Consultation Response

National Development Framework.
- Assessment of Onshore Wind
Energy Potential in Wales.

23 October 2019

Figure A1. – Recommended extension of Priority Area 14 to include NPT Refined Strategic Search Area E

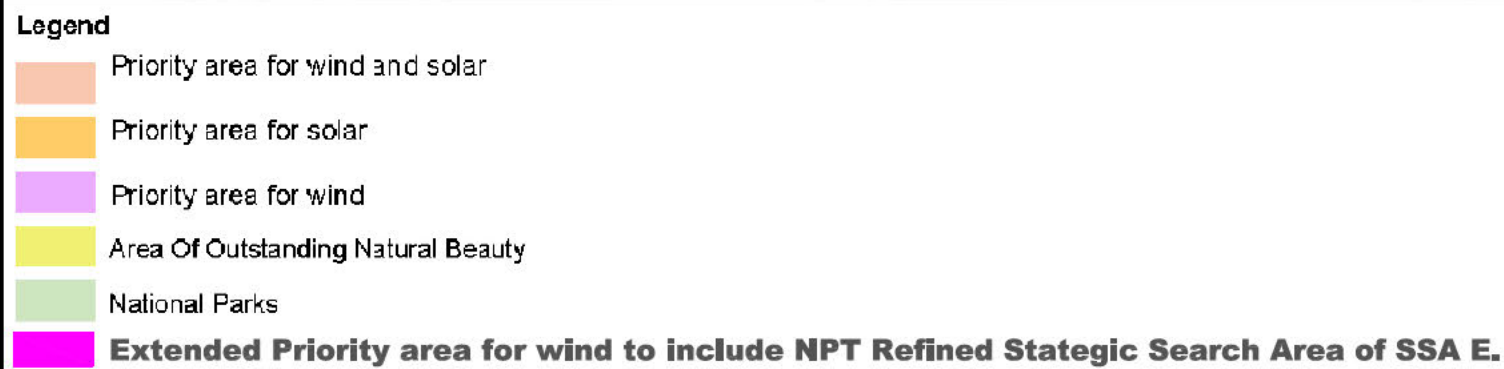
The Preferred Wind farm area of Zone 14 should be extended slightly to the east to include the refined Strategic Search Area of SSA E of the NPT Local Development Plan as shown in Fig A1.

Figure 11b - Proposed Refined SSA boundary

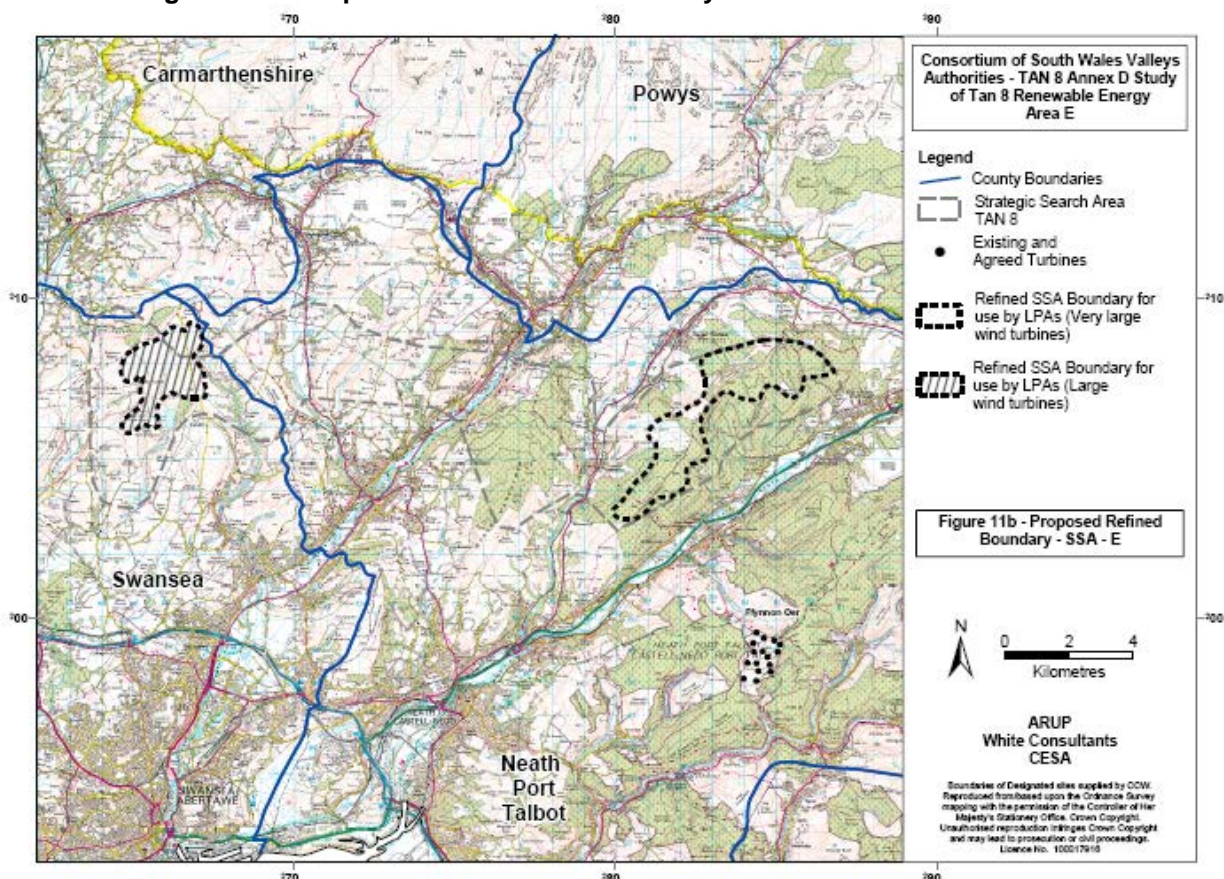
This Arup study was primarily a landscape and visual assessment exercise which sought to identify a 'Preferred Area or Areas' for large-scale wind farms broadly within the boundaries of the Strategic Search Area(s), working within the context of the indicative capacity targets for the SSAs (identified in TAN 8 in Table 1 Page 5). The study however also used a range of technical and other environmental data to inform its work. The Preferred Area is identified in Fig A2.

The report recommended that the site should form part of the Refined SSA boundary as it comprised the most environmentally acceptable areas.

Figure A.1 Refined Areas: SSA E

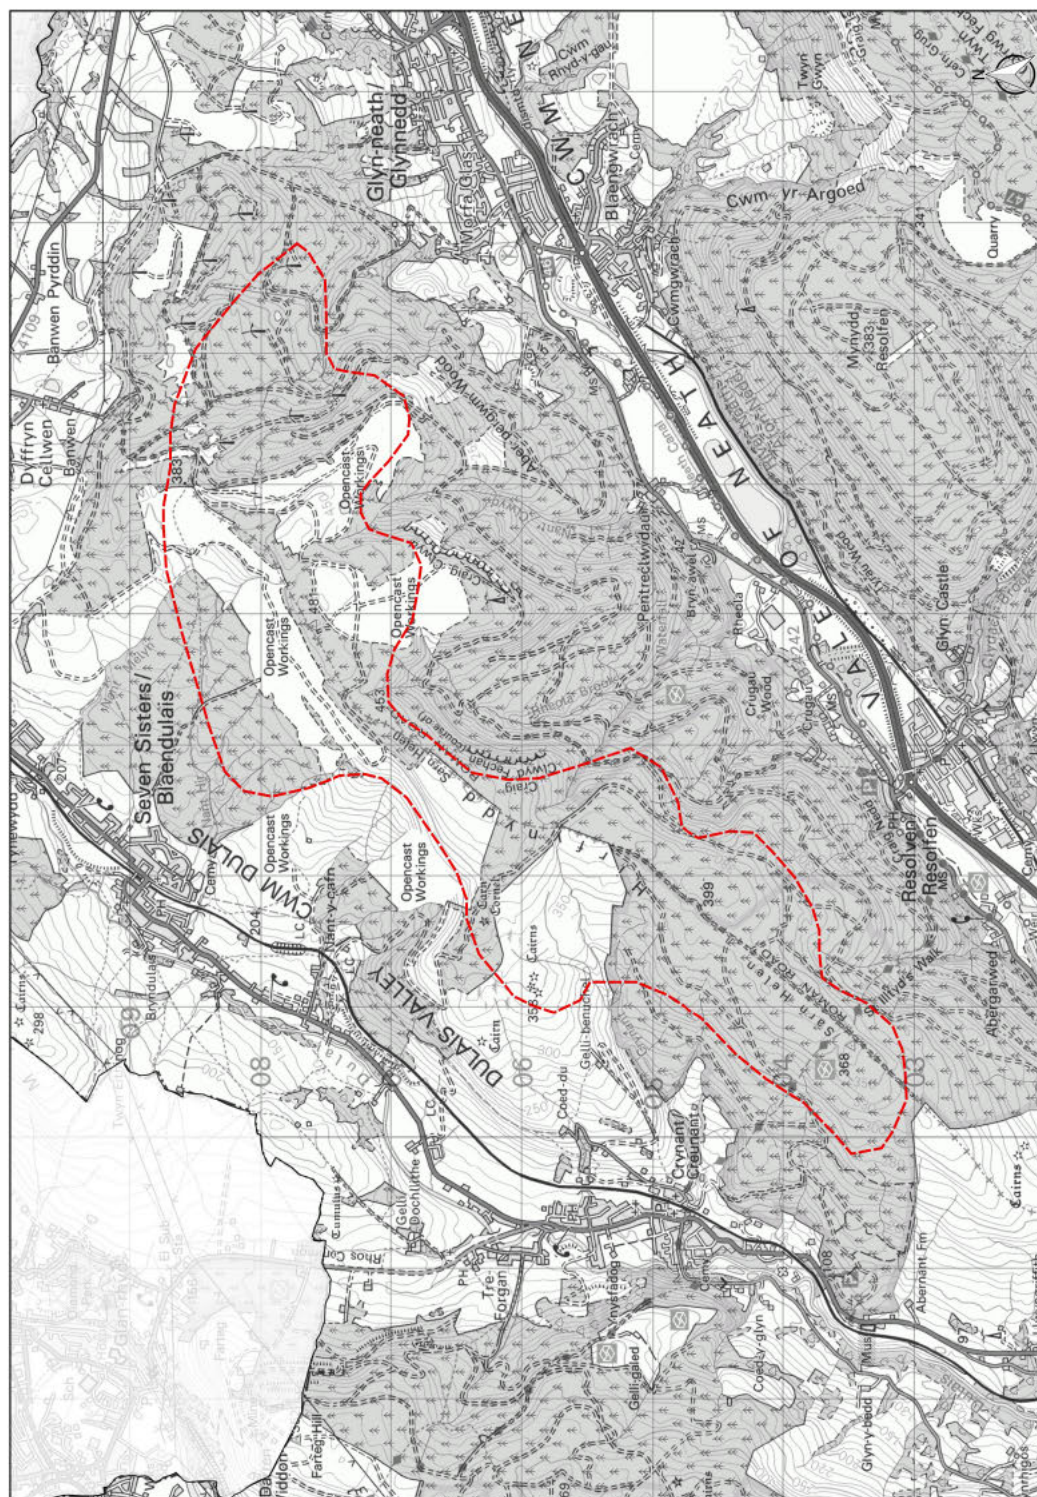
The refined boundaries were formally adopted through the Neath Port Talbot LDP process and are shown in Fig A3.

Intervisibility - 150m
- Brecon Beacons NP
PARE 14

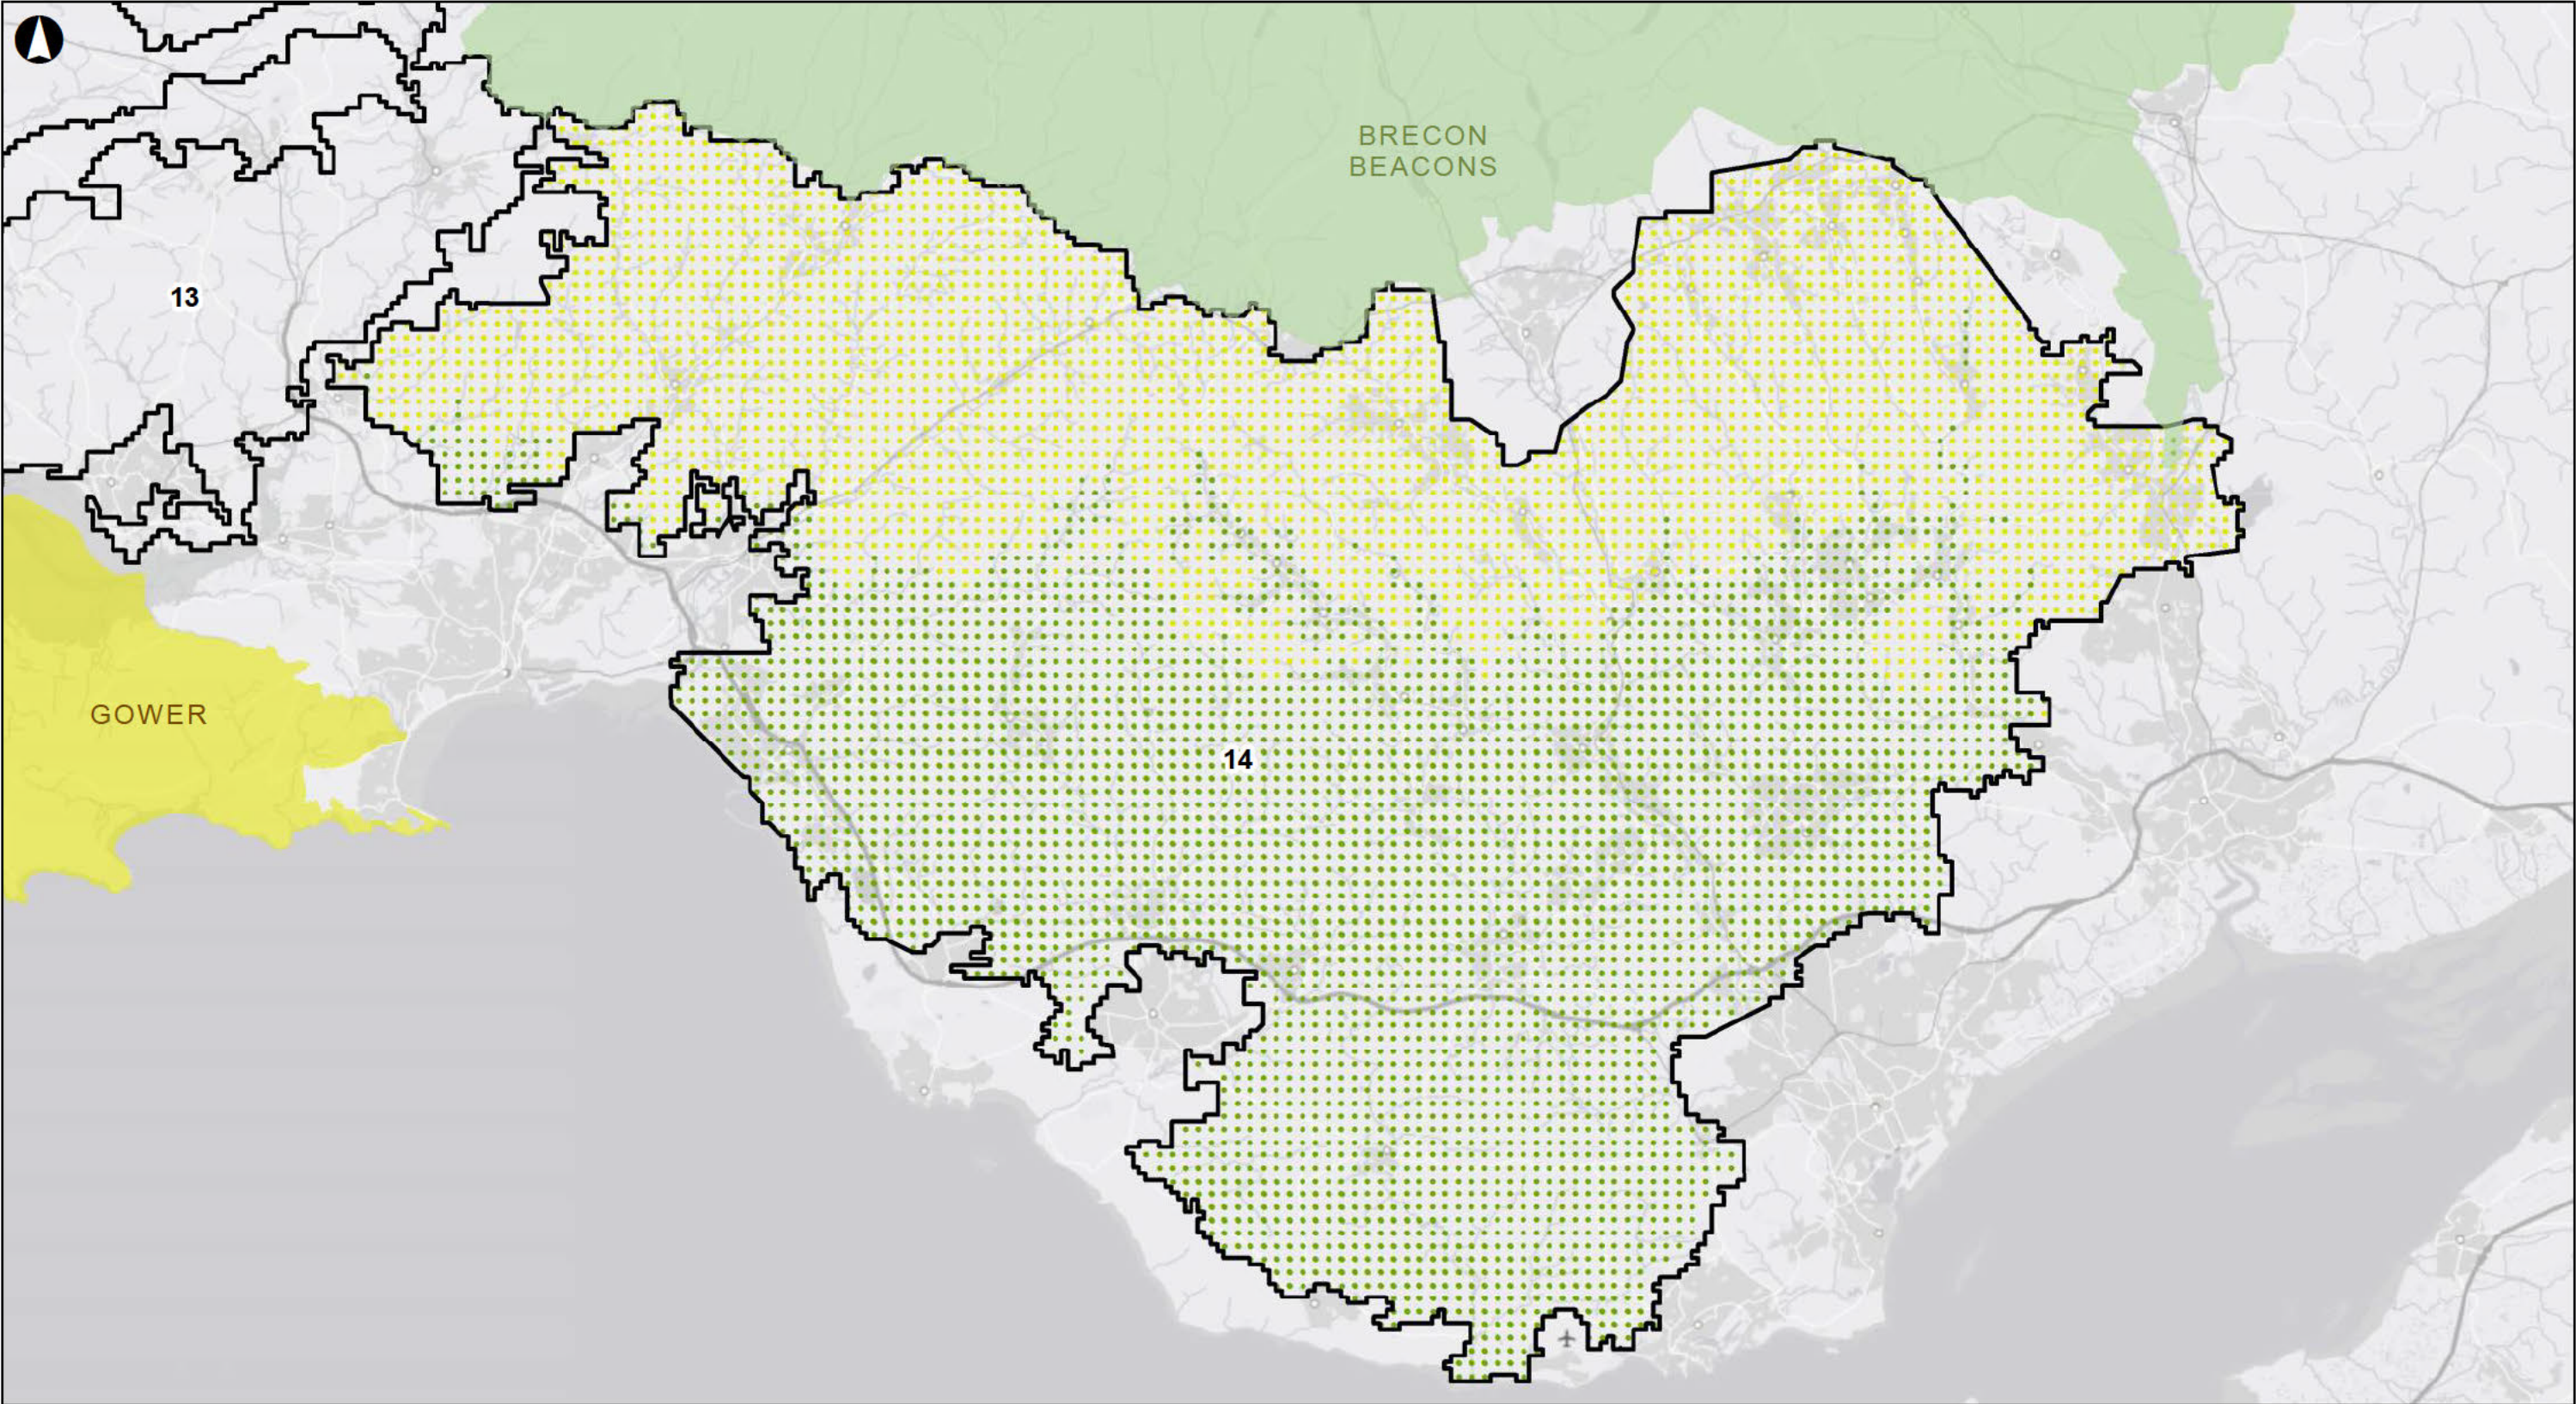
Indeed, **drawing 3.23 Intervisibility -150m Brecon Beacons NP PARE 14** [Fig A4.] of this study indicates the site is within the **1% to 25% range**. This is entirely acceptable within the conditions of *this* assessment and is in line with the earlier assessments. Therefore, for what reason is the area excluded?

To re-emphasise, drawing 3.23 Inter-visibility -150m Brecon Beacons NP PARE 14 [Fig A4.] of the study indicates the site is within the **1% to 25% range**. This is entirely acceptable within the conditions of **this** assessment. The removal of the site solely based on 250m tip heights would appear to be entirely arbitrary and unnecessary.

Intervisibility - 250m
- Brecon Beacons NP
PARE 14

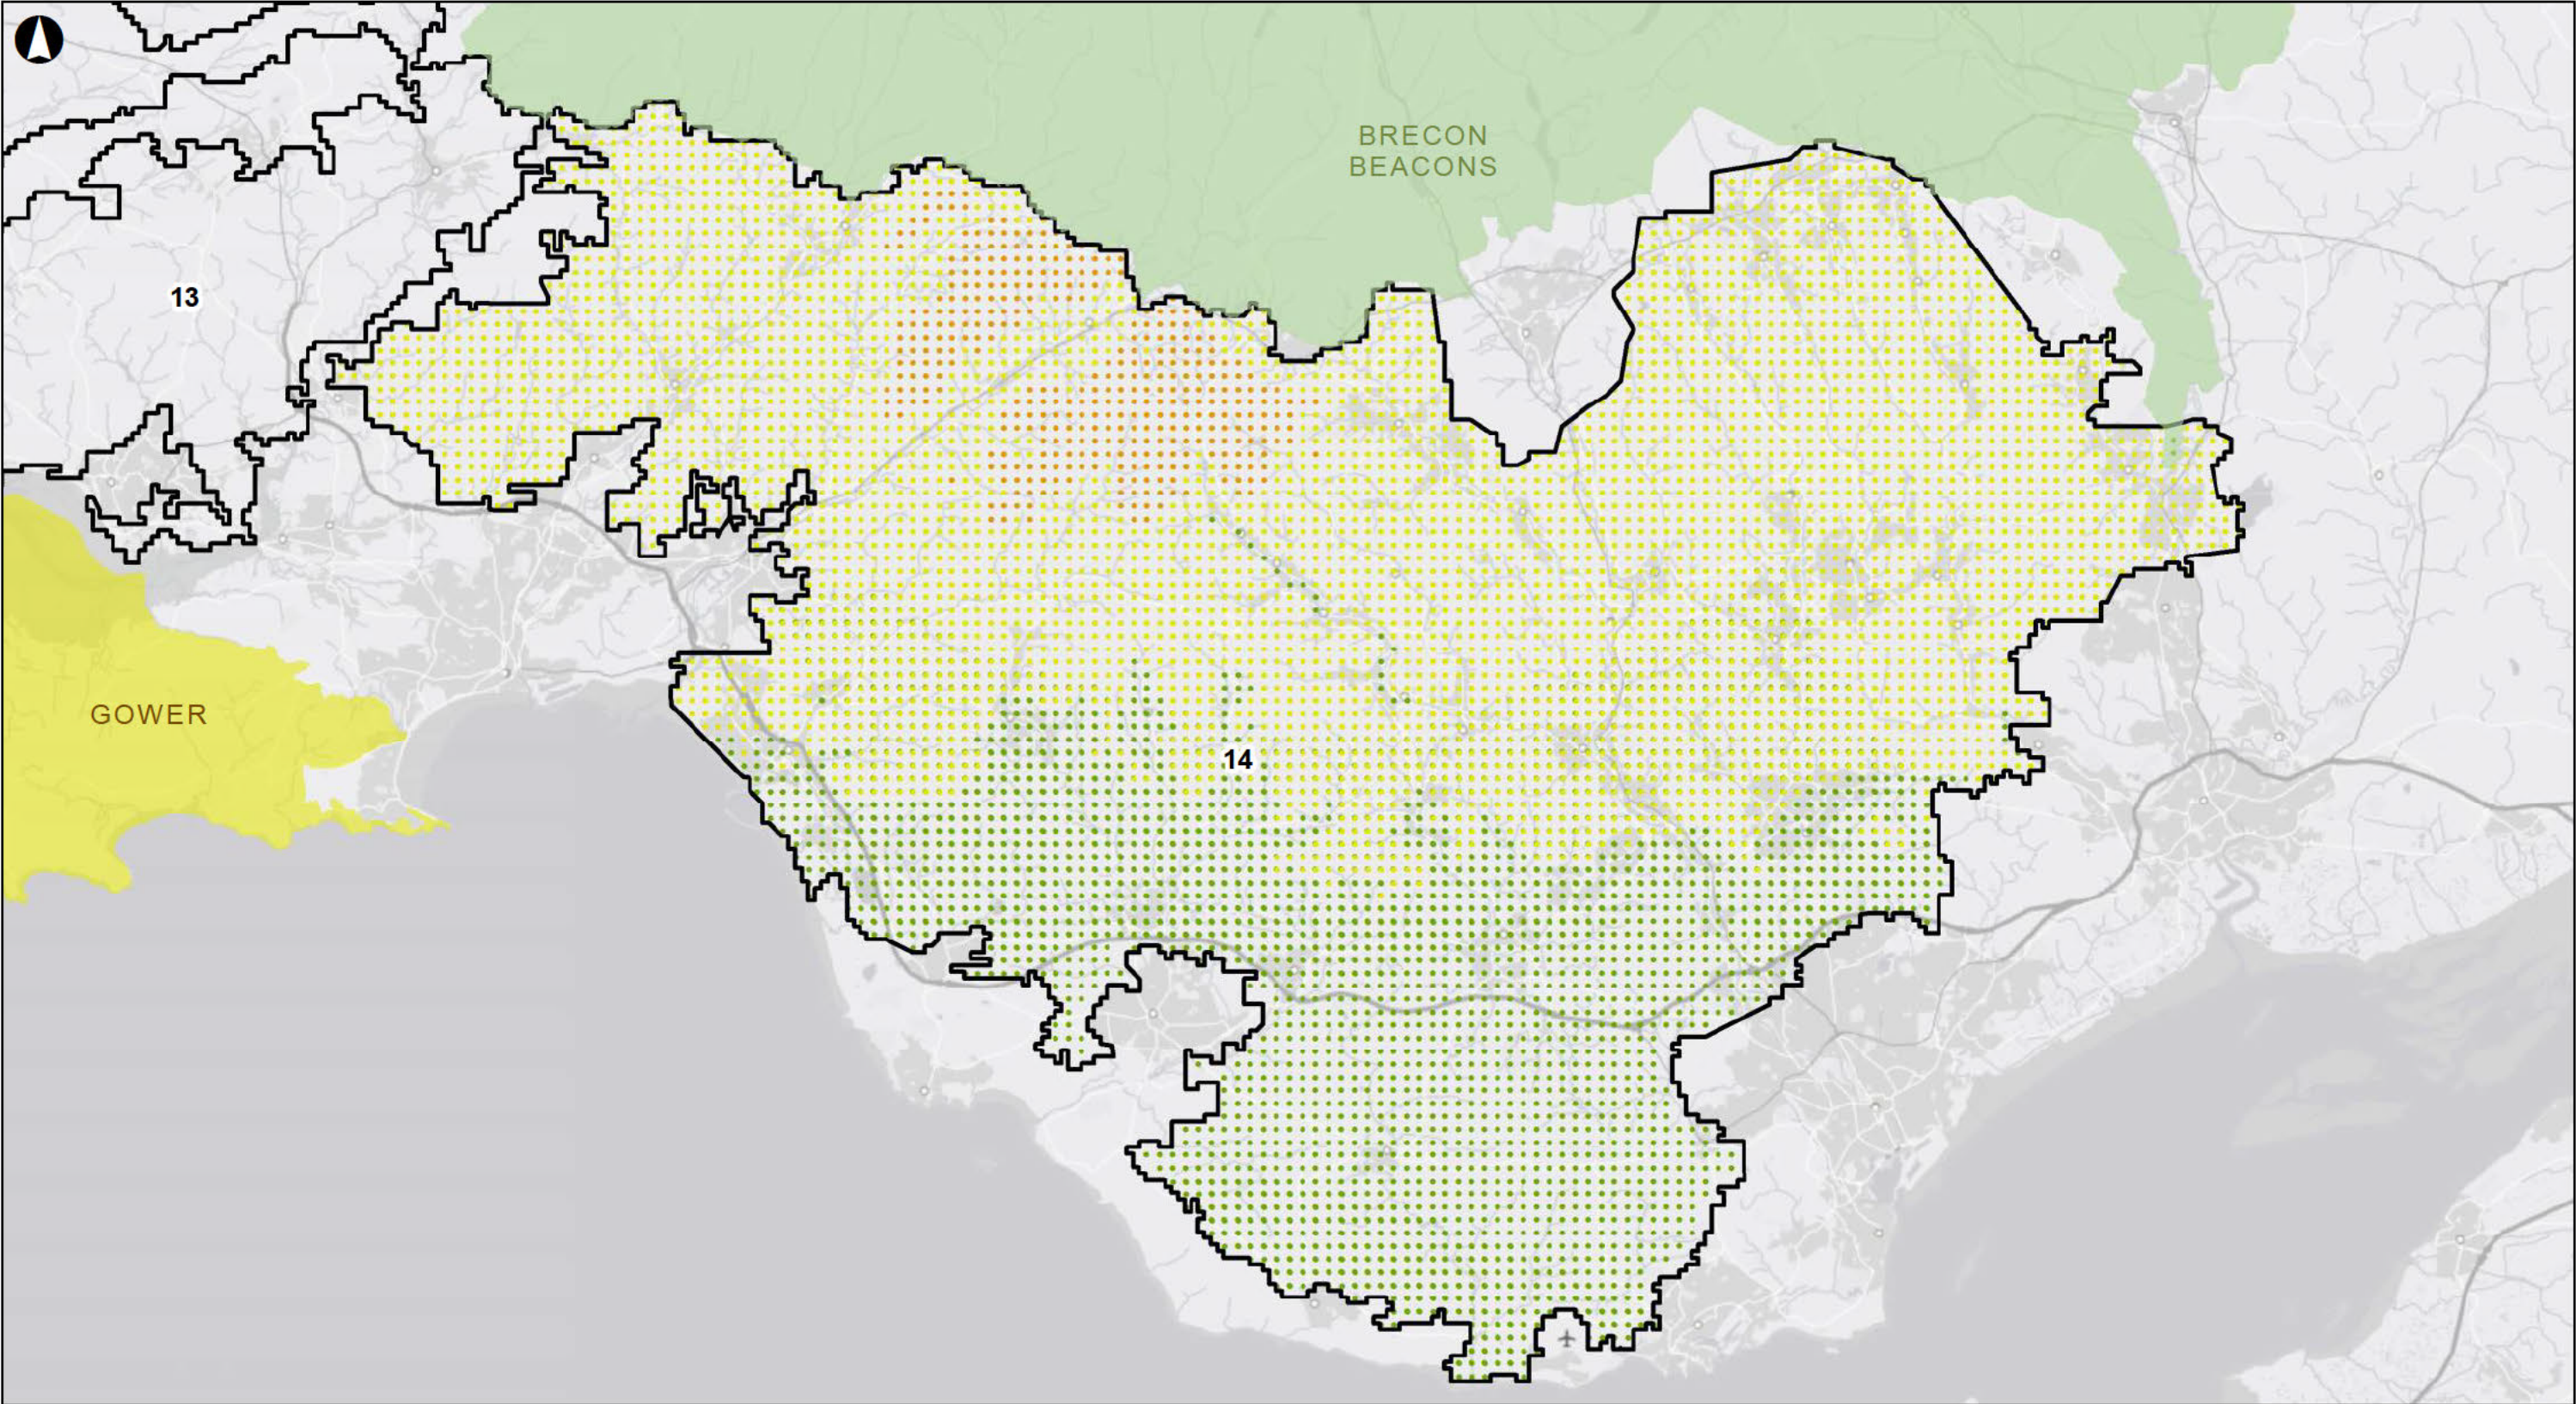
The evidence supporting this paragraph appears to be drawing 3.24 *Intervisibility -250m Brecon Beacons NP PARE 14*, [Fig A5.] which only considers turbines of 250m tip height.

Astonishingly, this refinement discounts the deployment of any turbines smaller than 250m.

A market analysis suggests that this would eliminate all onshore turbines that are currently available and in development. This surely must be an oversight? The above test is entirely arbitrary and represents an over-simplification of the complexities involved in the planning process.
